**INTERIM REVIEW OF  
US ARMY CORPS OF ENGINEERS  
LOWER SKAGIT RIVER FLO-2D MODEL**

**NORTHWEST HYDRAULIC CONSULTANTS INC  
20 DECEMBER 2007**

## Skagit River Flo2D Model Review

Figure 1: Preliminary USGS Lidar DEM vs. COE Photogrammetric Spot Elevations

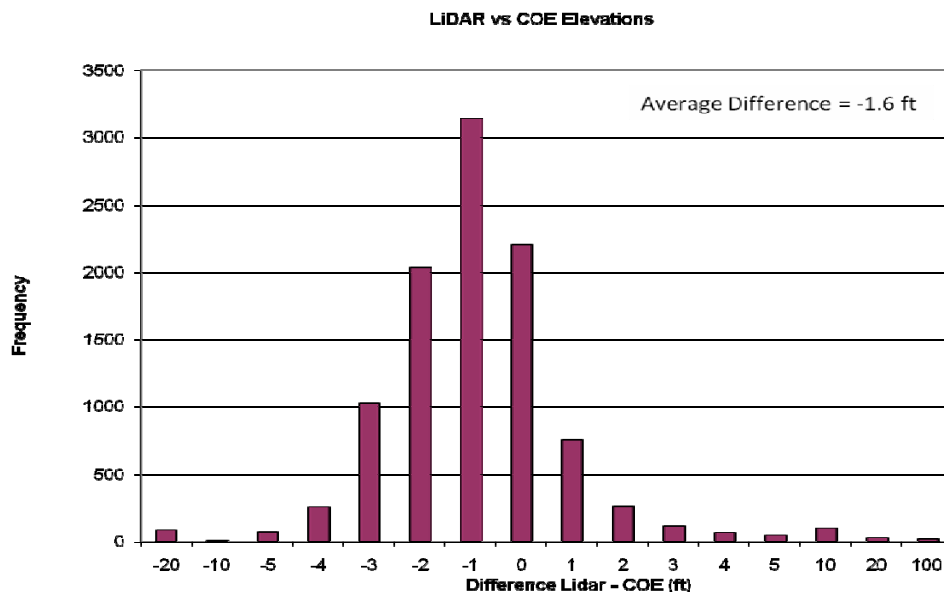
The lidar data averages 1.6 ft lower than the COE dataset for the 10,216 points we compared. There was no apparent geographic distribution to the differences, which are shown below.

For this review we did not consider elevation differences between the model and lidar of less than 2 feet to be significant. We conducted our review using the lidar and aerial survey data, but clearly further quality checks of the lidar data are warranted.

Figure 2: Left Bank Levee and Bank Elevation Profile

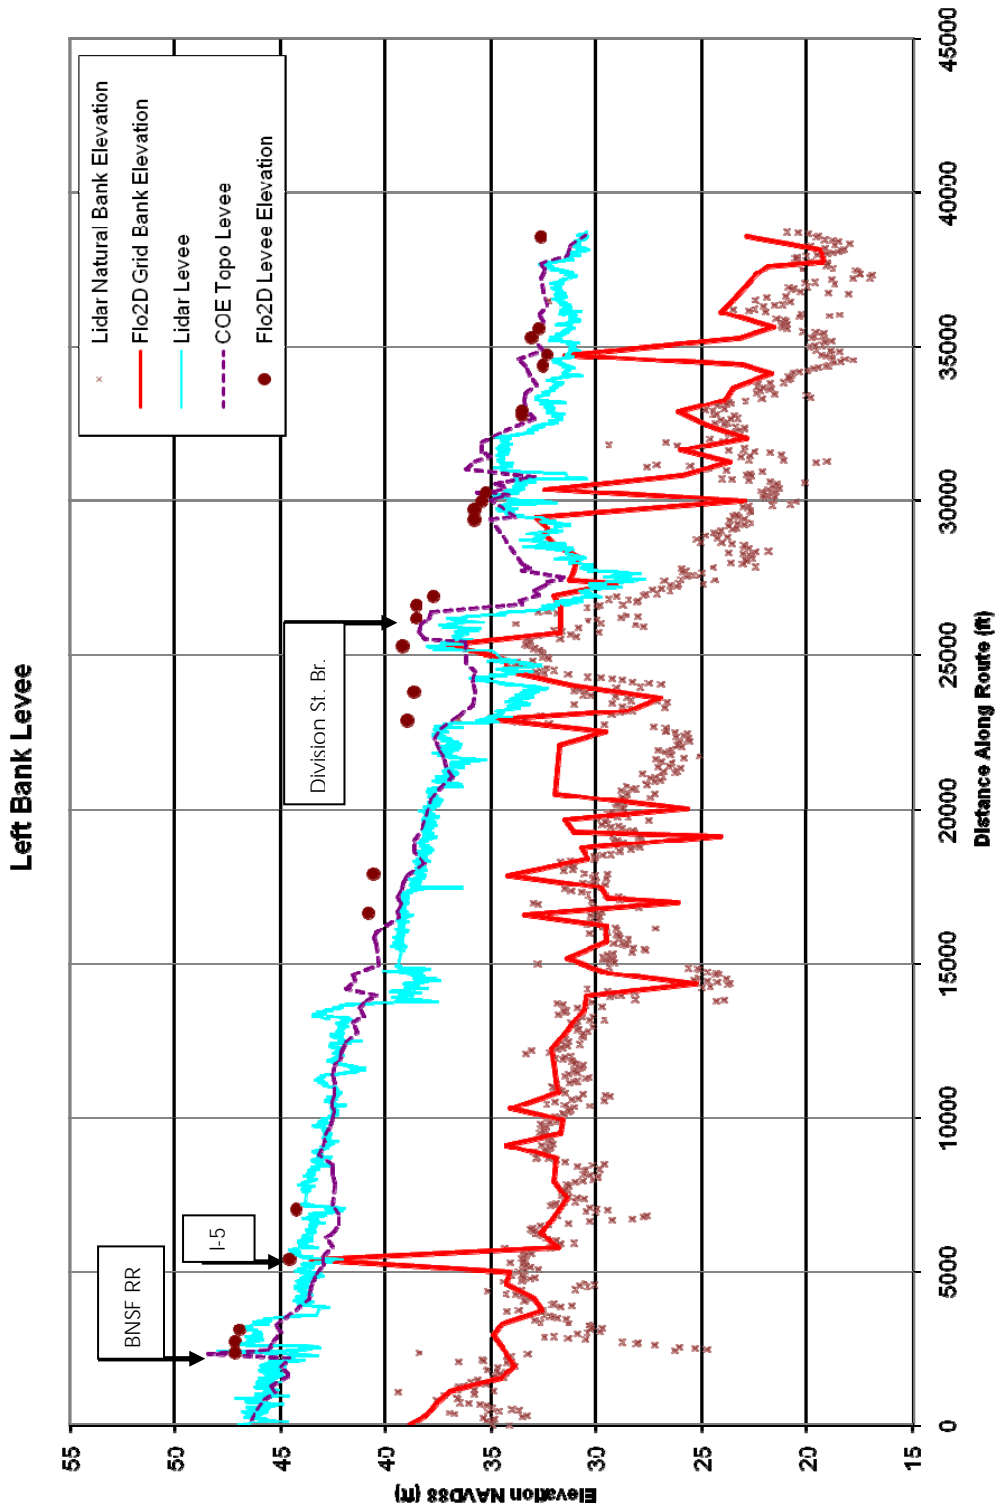
Bank elevations in the Flo-2D model generally agreed with the lidar data in the upper portions of both levees. Further down the river there are numerous locations where the modeled bank elevations appear to vary between the natural bank elevations and the

levee crest elevations. The modeled levee crest elevations vary from good agreement with the lidar data to up to 3 feet above it. Also plotted are the levee crest elevations from the Corps topographic survey.

The consequences of inaccurate bank and/or levee crest elevations are complex and may include both under and over predicting water surface elevations. Where the model has bank elevations that are erroneously set at the levee elevations, removing the levee to follow the FEMA policy will have no effect. In locations where the levee profiles are too high, the volume of overbank flow from levee overtopping will be underestimated. This could cause higher flood levels on the opposite overbank under the FEMA levee removal policy simulations.

- Our review identified areas of bank, roadway and levee elevations that appear to be high based on the lidar data. If the lidar data are found to be accurate, then the model should be modified and rerun to investigate whether more accurate elevations significantly affect flood levels.

Figure 4: I-5 Roadway Profile and Water Surface Elevations

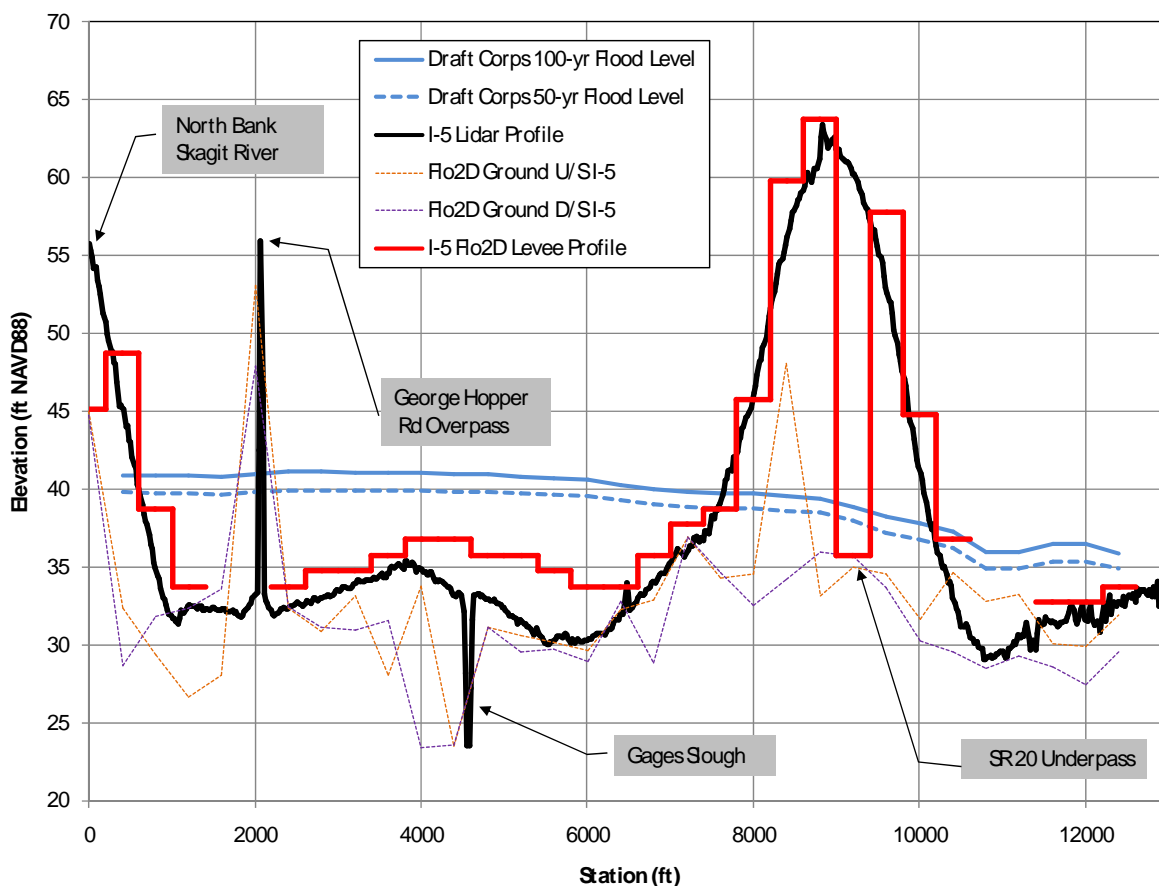
It appears that the model may not accurately represent the I-5 roadway crest elevations in the area beginning south of Gages Slough and extending north to where the roadway rises to cross over Highway 20. The lidar shows the roadway is 3-5 ft lower over nearly 3000 ft in this area. Weir flow increases exponentially with depth, so if the lidar is correct the model could be underestimating the flow capacity across I-5 by a

substantial margin, an important factor governing upstream water levels through the core of Burlington.

- WSDOT has been asked to determine if there is any high accuracy I-5 roadway elevation information available to help evaluate the preliminary lidar data.
